Docket No. 50-336  
B14906

Millstone Nuclear Power Station, Unit No. 2  
Revision 1 to Request for Relief from Section XI of  
ASME Code Examination Requirements

RR-10 REVISION 1, Reactor Coolant System Pipe to Reactor Vessel  
Nozzle and Pipe to Elbow Welds.

FIG. IWB-2500-8 SIMILAR AND DISSIMILAR METAL WELDS IN COMPONENTS AND PIPING (CONT'D)

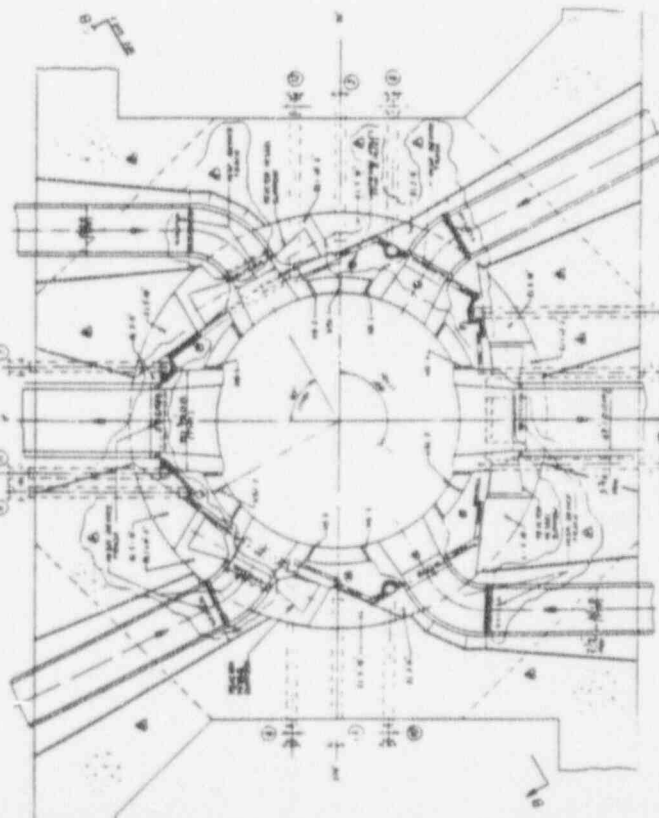
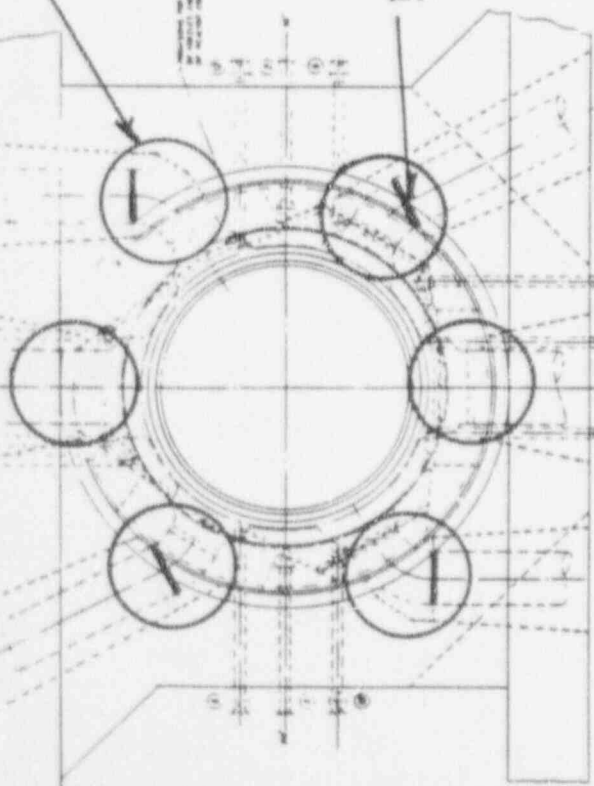
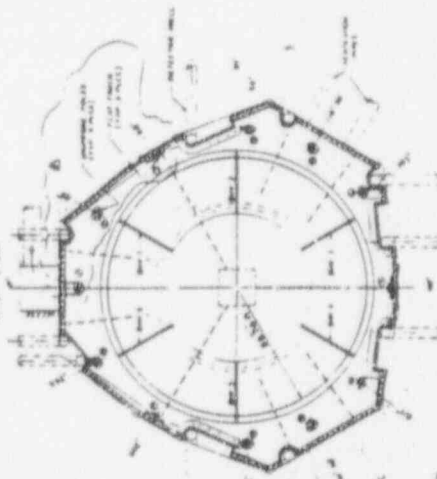
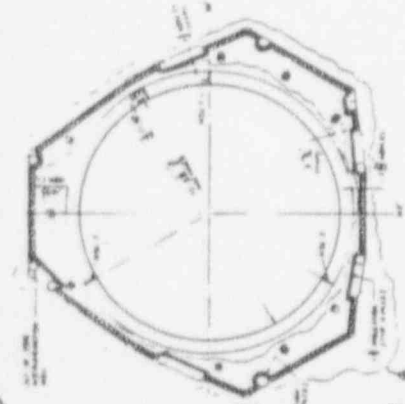
In lieu of performing the surface examination, a full-volume ultrasonic examination will be performed from the internal surface in accordance with ASME Section XI and Regulatory Guide 1.150. The ultrasonic examination will include 100 percent of the volume "A-B-E-F" as shown on the attached marked-up copy of figure IWB-2500-8 (SK1). The calibration for the ultrasonic examination will demonstrate that the examination from the inside diameter surface can detect an outside diameter flaw (notch). These welds will also be subjected to a system leakage test in accordance with ASME Code Case N-498.

SKETCH #2  
MP-2, RR-10, REV 1

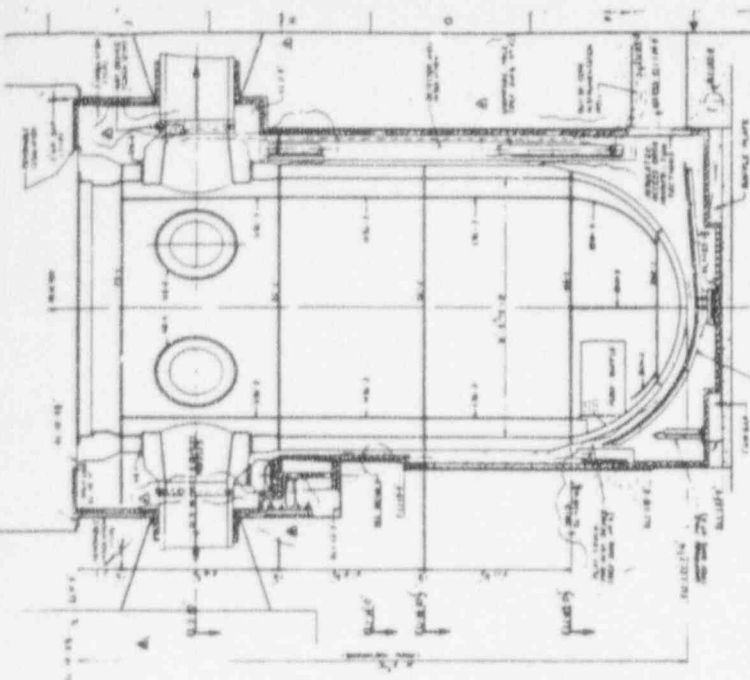
Relief is requested from performing the code-required surface examination on the outside diameter surface of an additional 4 reactor coolant pipe welds and their associated long seam welds. These welds are located completely within the primary shield wall, as shown on the attached revised drawing No. 25203-20146, sheet 97-1 (SK2).

<u>Pipe Weld No.</u>	<u>Zone Drawing No.</u>	<u>Code Item No.</u>
P-5-C-2	1-8	B9.11
P-9-C-2	1-10	B9.11
P-14-C-2	1-12	B9.11
P-18-C-2	1-14	B9.11
